SUBJECT: ISSUANCE OF AMENDMENT NO. 23 TO FACILITY OPERATING LICENSE
NO. NPF-63 REGARDING PRESSURE-TEMPERATURE LIMITS - SHEARON
HARRIS NUCLEAR POWER PLANT, UNIT 1, (TAC NO. 77587)

AMENDMENT NO. 23 TO FACILITY OPERATING LICENSE NO. NPF-63 - HARRIS, UNIT 1

Amendment No. 23
License No. NPF-63

SAFETY EVALUATION BY THE OFFICE OF NUCLEAR REACTOR REGULATION
SUPPORTING AMENDMENT NO. 23 TO FACILITY OPERATING LICENSE NO. NPF-63
CAROLINA POWER & LIGHT COMPANY
SHEARON HARRIS NUCLEAR POWER PLANT, UNIT 1
DOCKET NO. 50-400

FIGURE 3.4-2

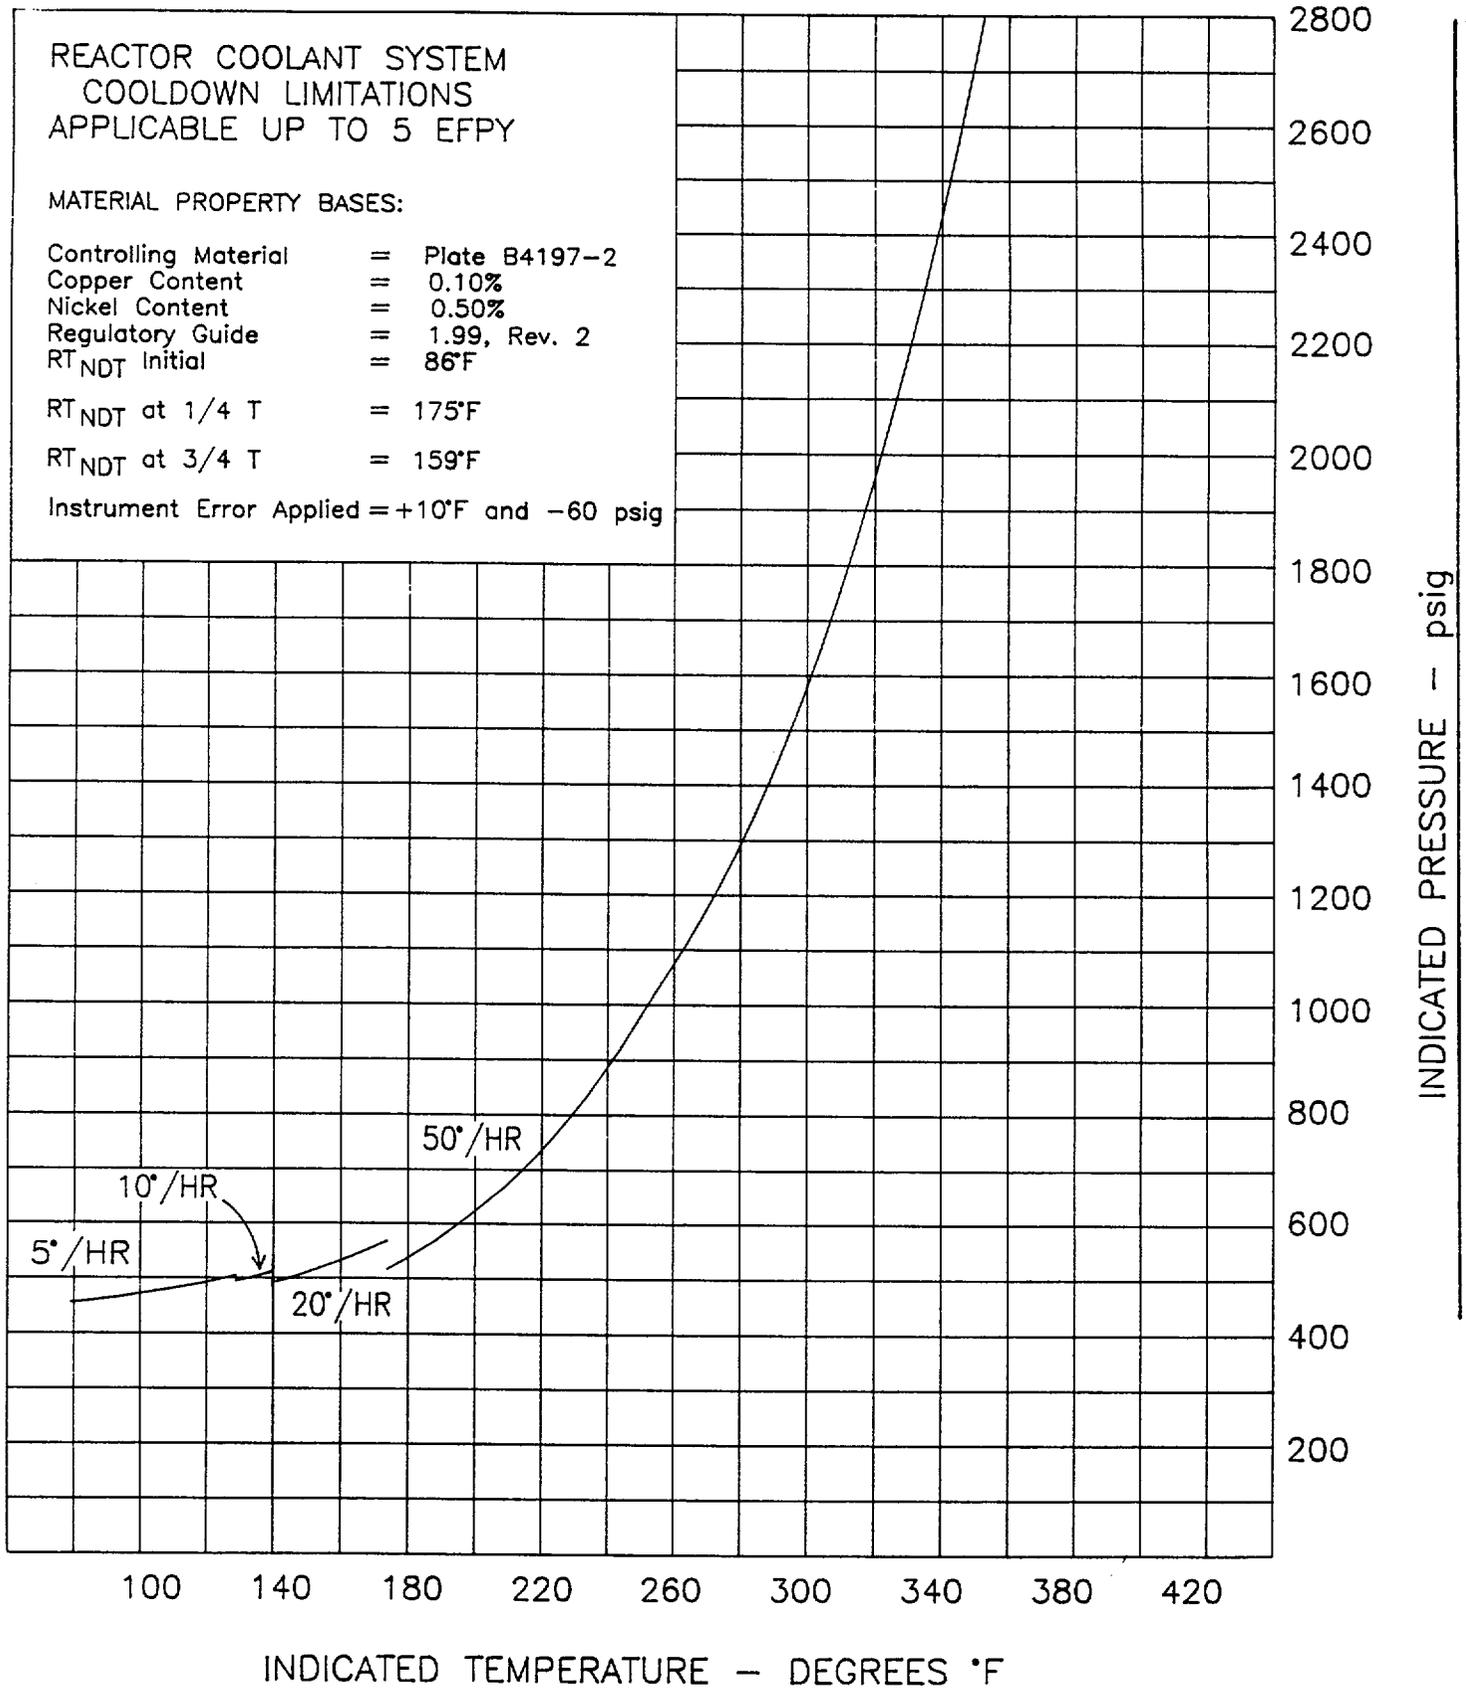
The amendment revises the reactor coolant system (RCS) pressure/temperature limits of Technical Specifications (TS) 3.4.9.1 and 3.4.9.2 to protect the reactor pressure vessel (RPV) from the potential of brittle fracture as the RPV neutron exposure increases from three (3) effective full power years (EFPY) to five (5) EFPY. In addition, the low pressure overpressure protection (LTOP) set points are adjusted accordingly and an effective lower temperature limit for usage of the LTOP set points has been added to ensure that the set points are used only in the region where the system can provide the necessary protection.

The licensee used the method in RG 1.99, Revision 2, to calculate an ART of 175°F at 1/4T and 159°F at 3/4T for the same limiting metal. Substituting the ART of 175°F into equations in SRP 5.3.2, the staff verified that the proposed P-T limits for heatup, cooldown, and hydrotest meet the beltline material requirements in Appendix G to 10 CFR Part 50.

Controlling Material = Plate B4197-2
 Copper Content = 0.10%
 Nickel Content = 0.50%
 Regulatory Guide = 1.99, Rev. 2
 RT_{NDT} Initial = 86°F
 RT_{NDT} at 1/4 T = 175°F
 RT_{NDT} at 3/4 T = 159°F
 Instrument Error Applied = +10°F and -60 psig

FIGURE 3.4-4

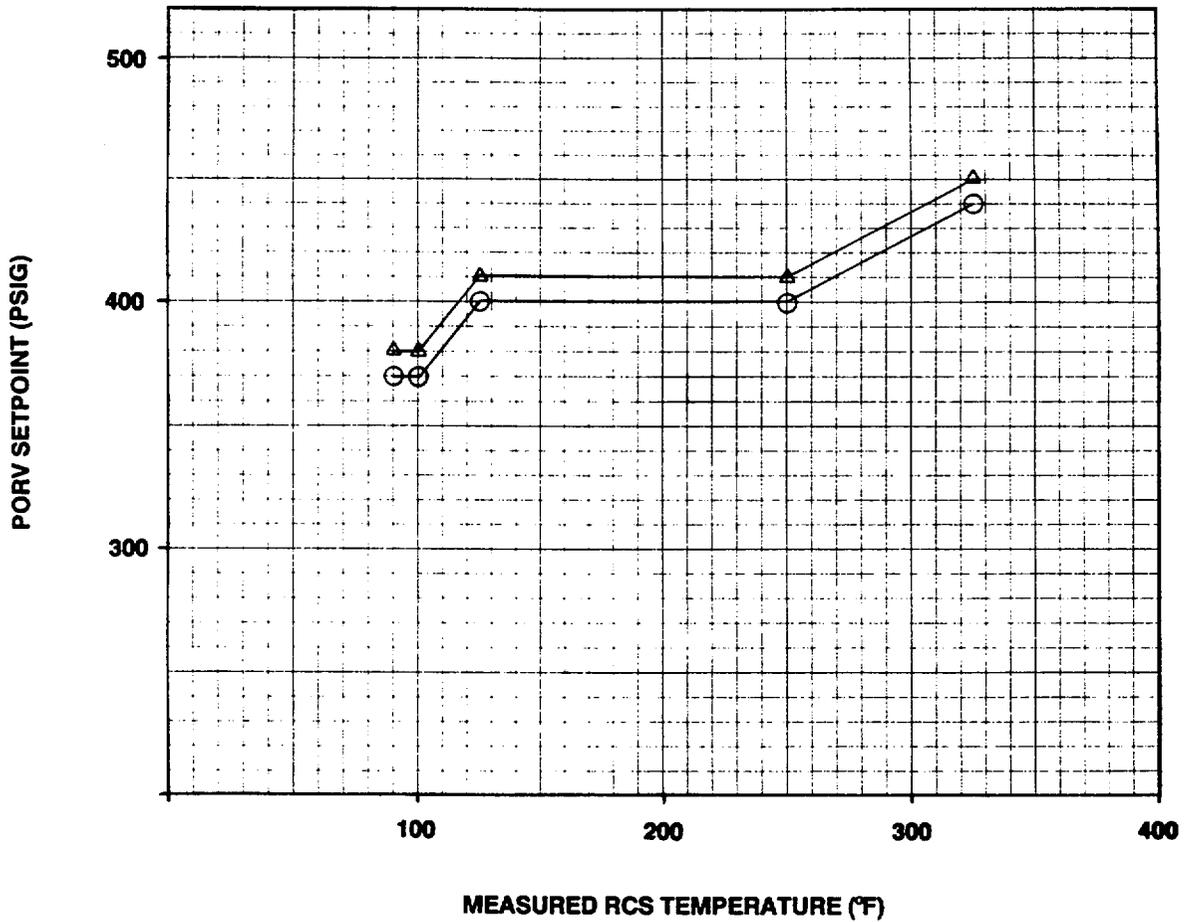
In addition, the proposed change will add an effective lower temperature limit to TS Figure 3.4-4 for use of the LTOP system to maintain protection of the RCS. This modification would extend the low and high PORVs setpoint lines from 100°F down to 90°F. The limit was added to ensure that LTOP setpoints are used only in a region where the system can provide the necessary protection. Below 90°F, overpressurization protection is provided by administrative procedure that will implement TS 3.4.9.4(a) in which the reactor coolant system is depressurized with a vent area greater than 2.9 square inches. All other LTOP setpoint design bases remain the same as those used previously for the three EFPY

setpoint determination. The staff reviewed the current and the extended PORV's setpoints to the new derived pressure-temperature curves and concluded that the setpoints for the PORVs are within the allowable range and are, therefore, acceptable.

* Credit may only be taken for the setpoints when the RCS cold leg temperature $\geq 90^{\circ}\text{F}$.

<u>RCS TEMP OF</u>	<u>LOW PORV * PSIG ○</u>	<u>HIGH PORV * PSIG △</u>
90	370	380
100	370	380
125	400	410
250	400	410
300	427	437
325	440	450
